DOCUMENT CHANGE REQUEST

DCR number 439	Changes required for: N/A	Originator: S Jeffery - ESCC
Date: 2008/11/03	Date sent: 2008/11/03	Organisation: ESA/ESTEC
Status: IMPLEMENTED

Title:	Transistors Low Power PNP, based on type 2N3962		
Number:	5202/015	Issue:	1

ESCC Detail Specification No. 5202/015

1.6 PHYSICAL DIMENSIONS AND TERMINAL IDENTIFICATION

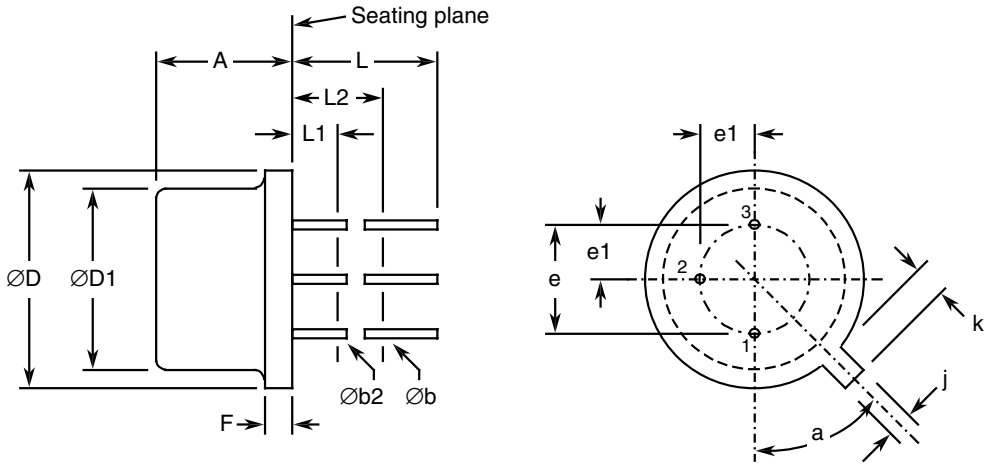
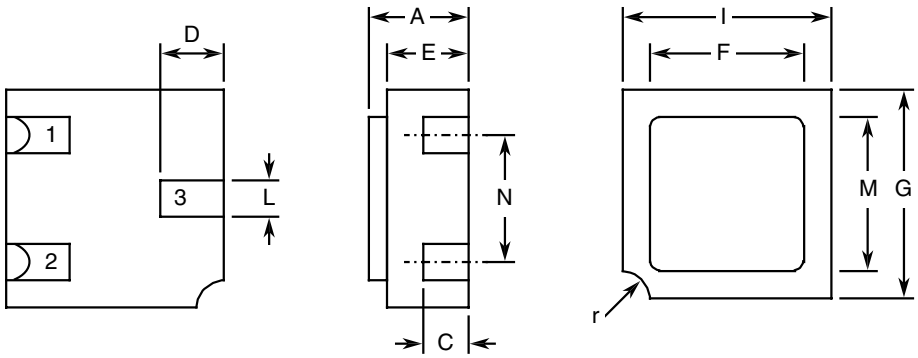
8. Figure 2 re-named "Physical Dimensions and Terminal Identification" and amended to reflect the TO-18 and CCP packages currently supplied.

1.7 FUNCTIONAL DIAGRAM

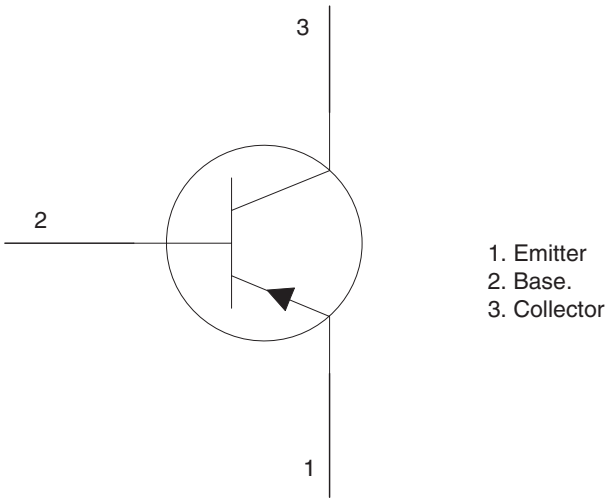
9. Figure 3, Functional Diagram: A note applicable to the Chip Carrier Package (Note 2) has been added.

NOTES:
1. For TO-18, the collector is internally connected to the case.
2. For CCP, the lid is not connected to any terminal.
